**To: Oshawa Safety & Facilities Services  
Committee**  
**From: Tony Trinidad et Residents of Arborwood  
Drive**

**Re: Report SF-24-16 - Harmony Creek Trail  
Extension**

April 12, 2024

b) Beaver Activity continuing causing flooding and trees cut

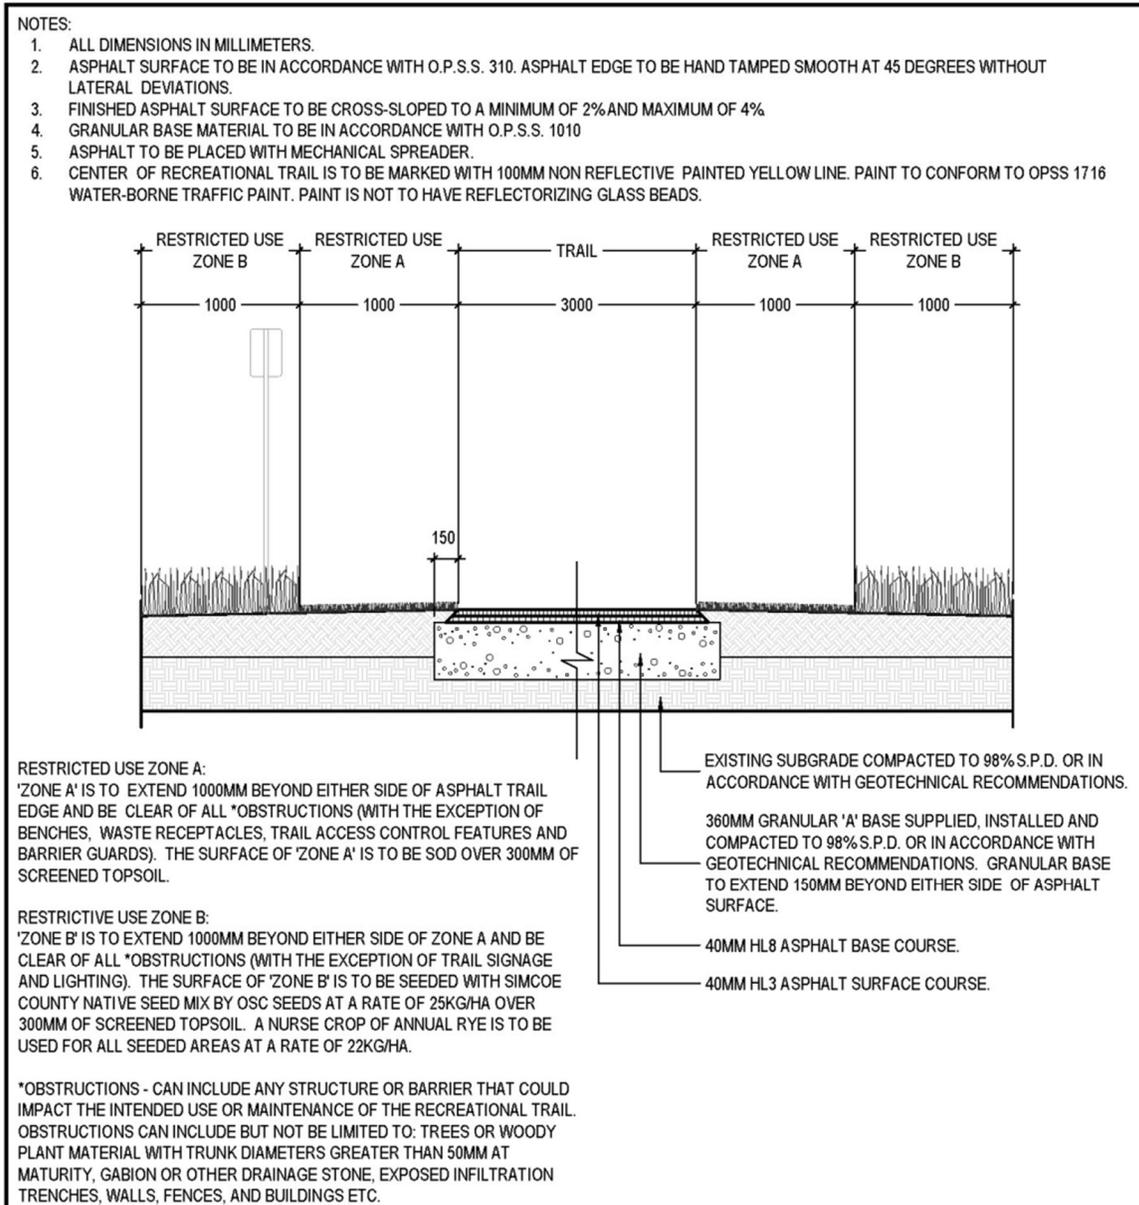
a) Picture of where bridge crossing Esterbrook park – Note large gap of land that is typically

submersed in water which would mean the requirement of a longer bridge.
